ARCHITECT'S PROJECT #1708 4J SCHOOL DISTRICT CIP# 600.766.000
4J SCHOOL DISTRICT
NORTH EUGENE HIGH SCHOOL
TRACK SHED 2018
200 SILVER LANE
EUGENE, OREGON 97404

This addendum, consisting of a total of (3) pages, forms a part of the Contract Documents and modifies the original Drawings dated February 5, 2018. Acknowledge receipt of this Addendum in the space provided on the Bid Form. Failure to do so may subject the Bidder to disqualification.

1 ROOF DETAIL @ PEAK & GUTTER

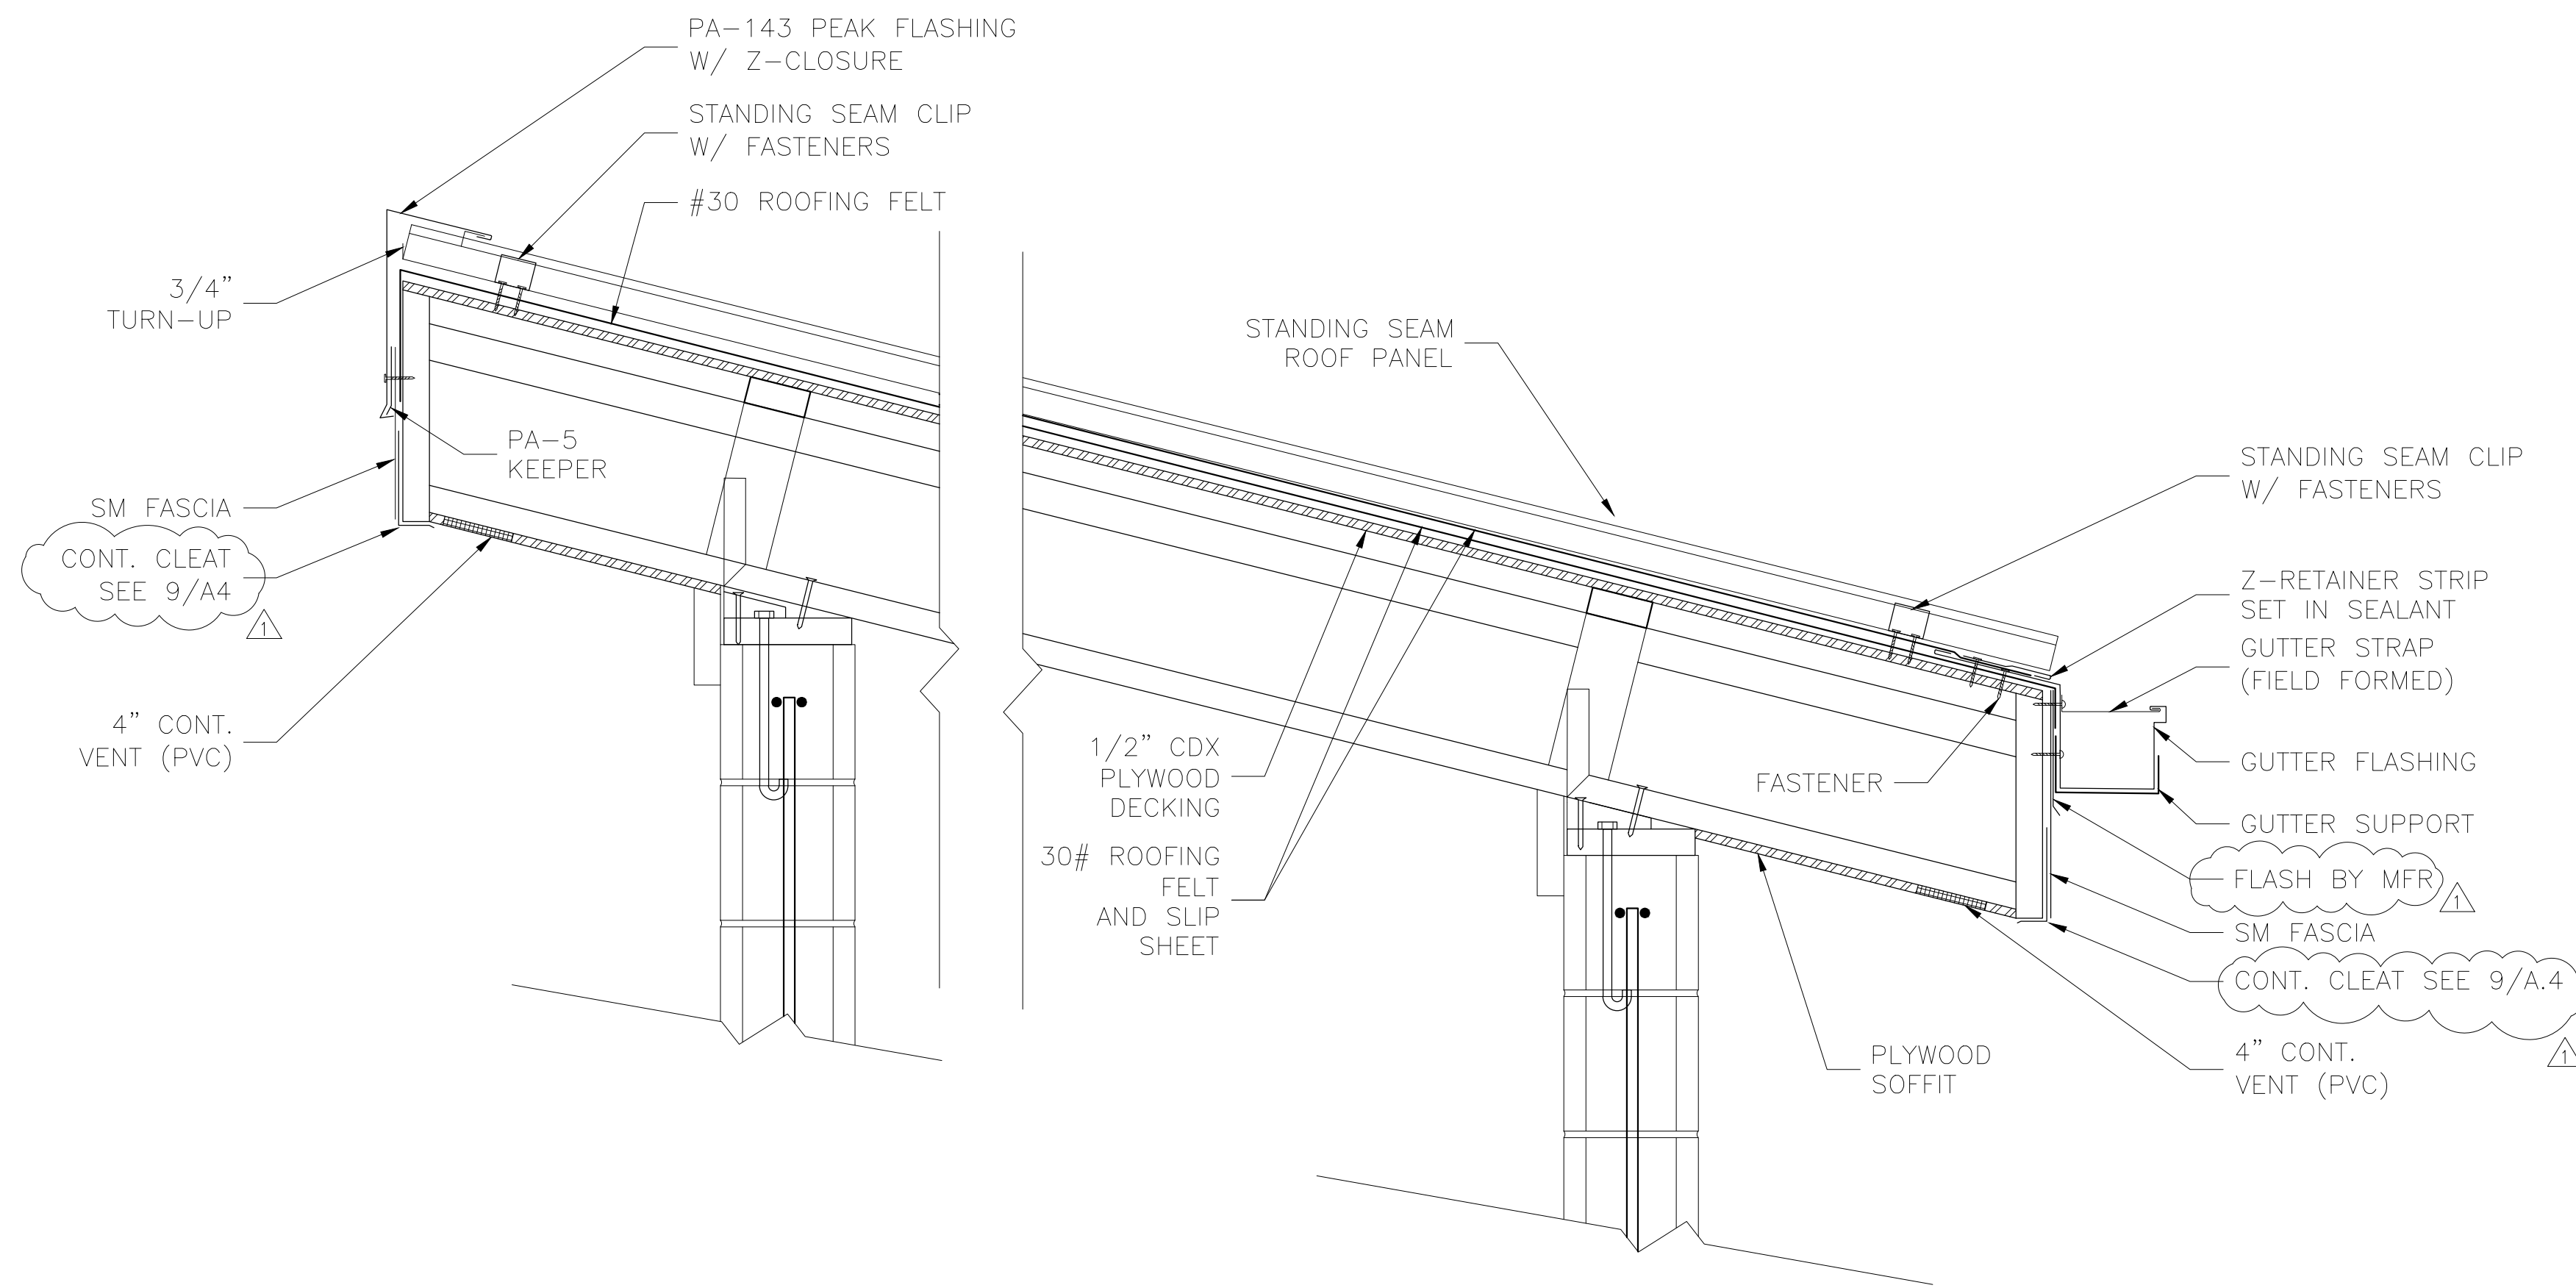
13. A4 Rev#1- Clarifications to 5/A4 Foundation/Cornice Section Detail: continuous PVC soffit vent.
14. A5 Rev#1- Clarifications to flashings in Detail 1/A5Roof Detail Peak and Gutter.
